McGOWIN NORTH SUBDIVISION, UNIT 2

APPLICATION NUMBER 16 DATE December 4, 2003
 APPLICANT McGowin North Subdivison, Unit Two
 REQUEST Subdivision

McGOWIN NORTH SUBDIVISION, UNIT TWO

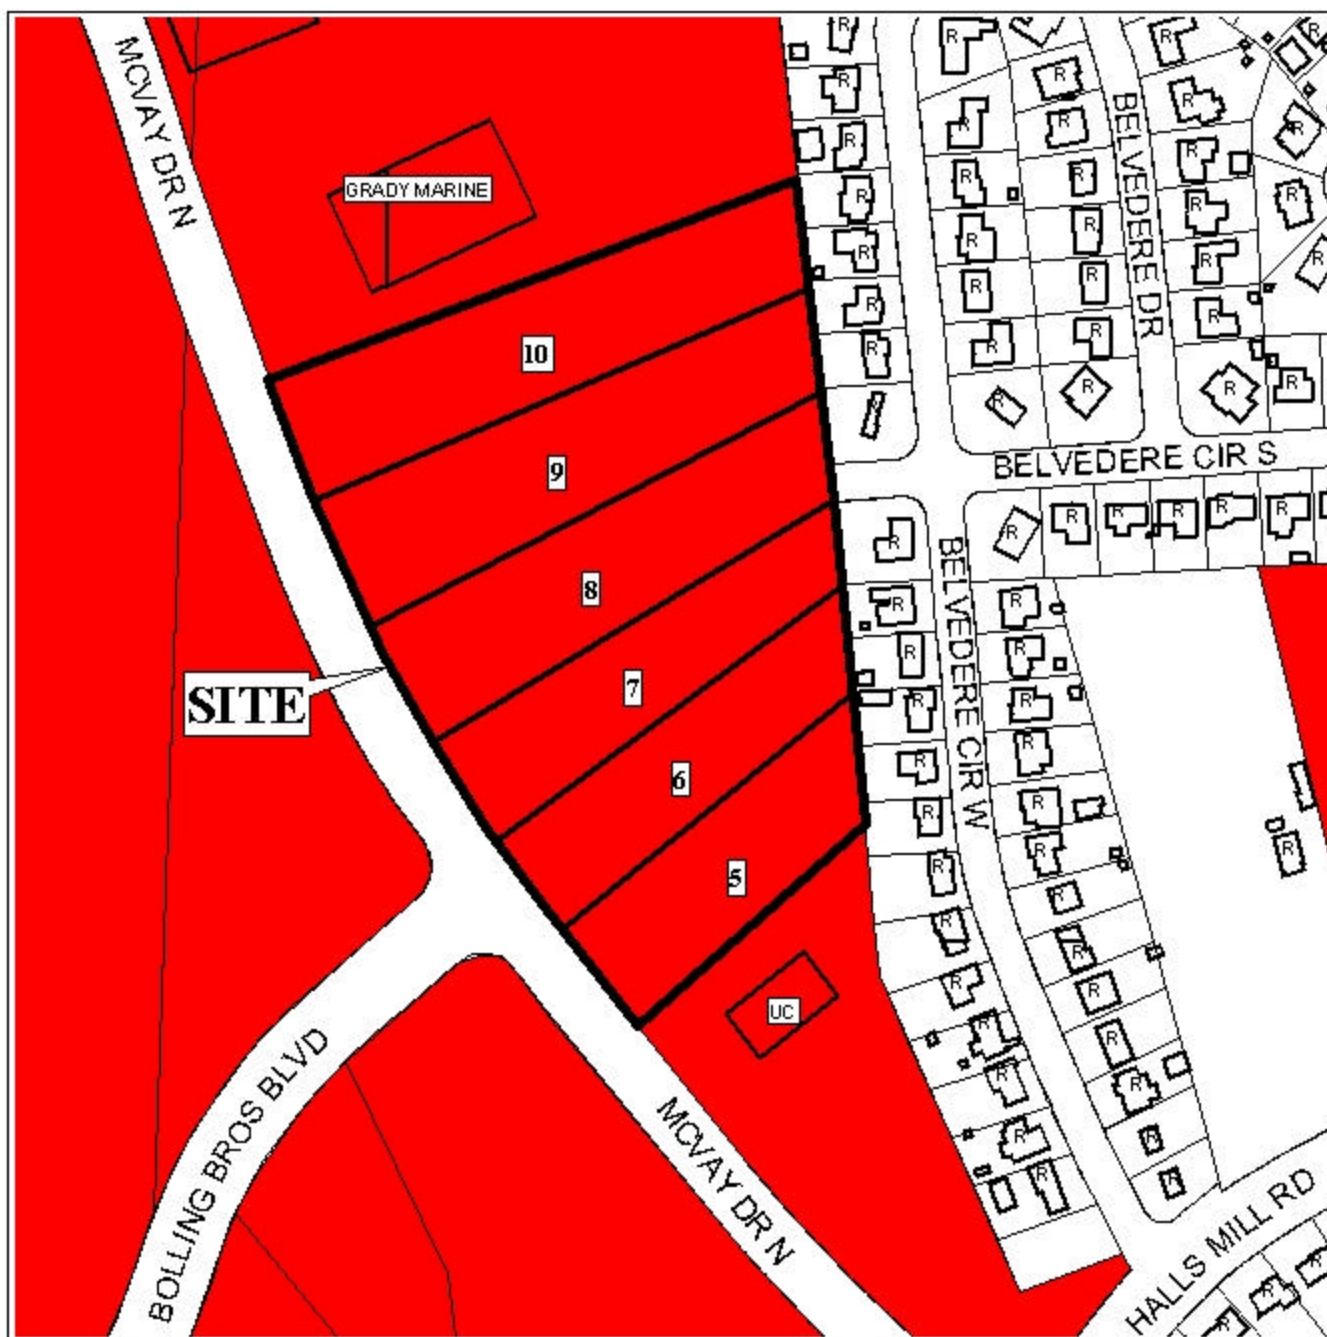
Engineering Comments: Significant outfall problems associated with development of this property and will seriously aggravate drainage concerns of Belvedere Park Sub. Outfall problems should be resolved by developer prior to development of property. Must comply with all stormwater and flood control ordinances. Any work performed in the right-of-way will require a right-of-way permit.

Traffic Engineering Comments: Driveway numbers, size, location and design to be approved by Traffic Engineering and conform to AASHTO standards.

As proposed, Lots 5, through 10 would exceed the width to depth ratio, therefore a waiver of Section V.D.3. would be required.

The 25-foot minimum building setback lines are not shown but would be required on the final plat.

With a waiver of Section V.D.3., the proposed plat meets the minimum requirements of the Subdivision Regulations and is recommended for Tentative Approval subject to the following conditions: 1) the placement of a note on the final plat stating that the six lots should be limited to four curb cuts to McVay Drive; 2) the placement of a note on the final plat stating that direct access to Belvedere Circle South is denied; and 3) the placement of the 25-foot minimum setback lines on the final plat.
